SERVICE BULLETIN #1185

SUBJECT USE OF PROTECTOR PLATES, P/N 51632B

MODEL ALL

DATE 7/25/62

FIGURE 1

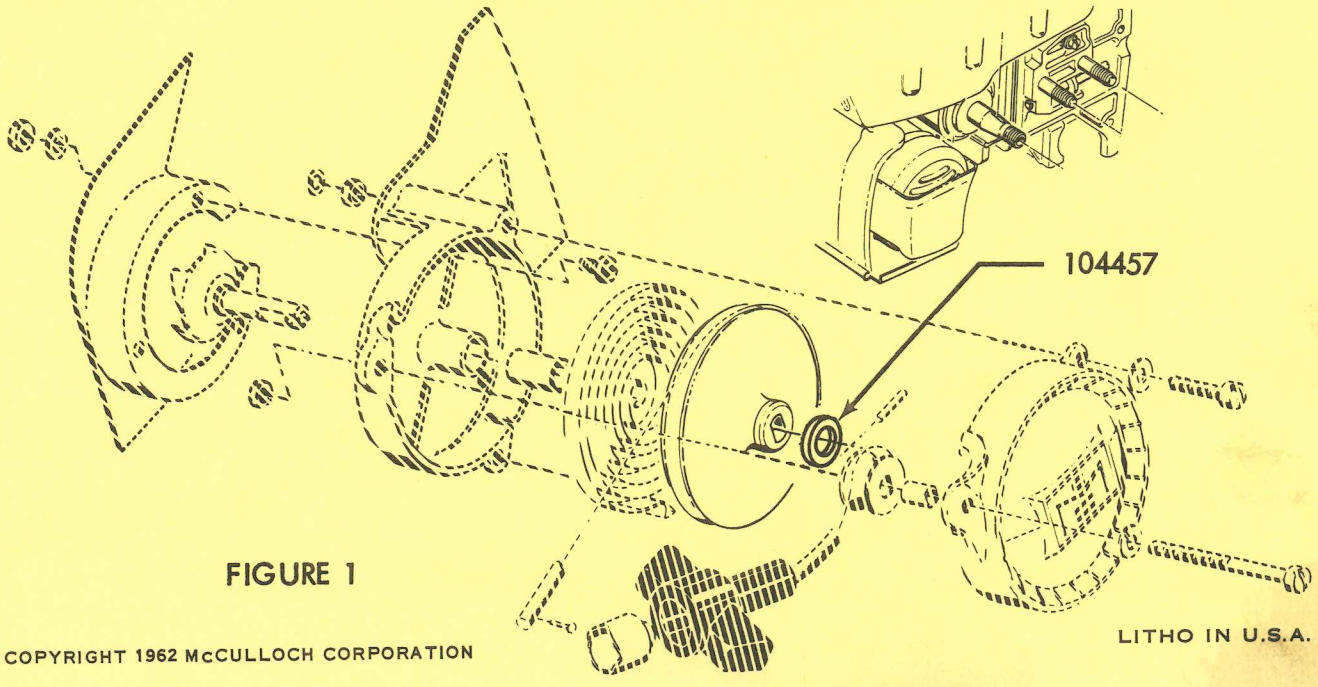
In order to maintain correct starter shaft engagement with the clutch on Model 1-76 chain saws, a new Starter Assembly, P/N 53844, must be used to compensate for removal of the protector plates. The difference between the old Starter Assembly, P/N 57661, and the new Starter Assembly, P/N 53844, on the Model 1-76 is in the position of the Spacing Washer, P/N 104457, on the starter shaft.

The Model 1-76 saw may be used either with or without protector plates but the spacing washer must be in the proper position on the starter shaft. If protector plates are being removed from a saw, be sure that the spacing washer is moved to the position shown in Figure 1. This is the washer position in Starter Assembly, P/N 53844. Conversely, if the protector plates are being added to a saw previously without them, be sure that the washer is changed to the position shown in Figure 2. This is the washer position in Starter Assembly, P/N 57661.

A. When protector plates are not used, the washer is placed outside the drum at the end of the starter shaft as shown in Figure 1.
